VILLAGE OF MONROE
Workshop Minutes
October 6, 2025

SUBJECT: 208 Business Center, LLC – **FEIS Review (FOURTH)**
File No. 201-3-3, 4, 7 & 8; Memo 110-25-003

Subject: 208 Business Center
FEIS Substantive/Technical Review

RE: Review of the FEIS

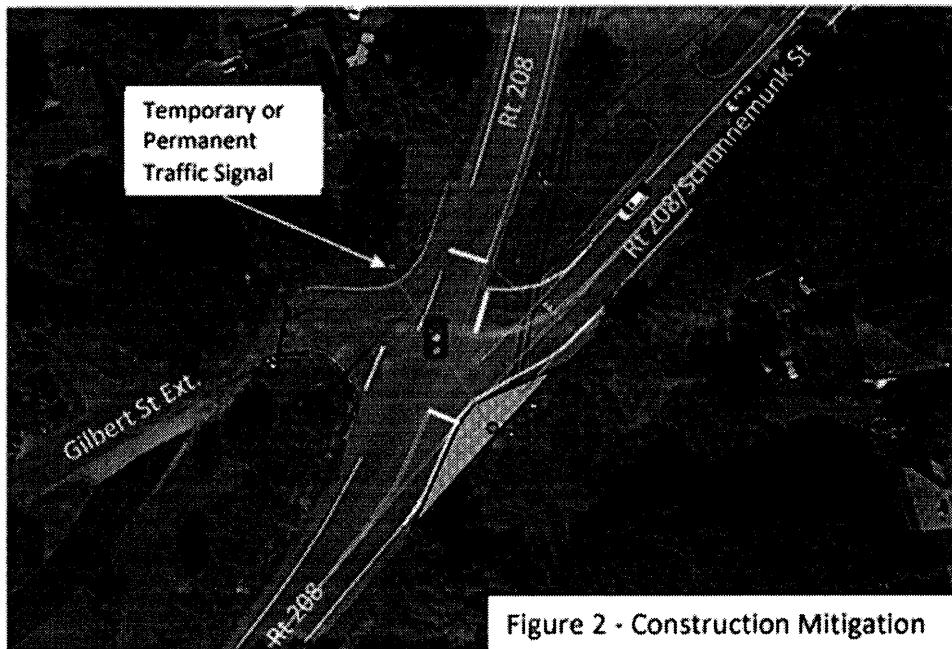
The Construction Management Plan does recommend an initial phase of construction that would partially improve the Route 208/Gilbert St/Schunnemunk St intersection and signalize it to better assist motorists through the intersection (see Figure 2 of the Construction management plan (reproduced below for convenience). Kimley-Horn agrees that this measure will facilitate access to the street for traffic using the Gilbert Street Extension.
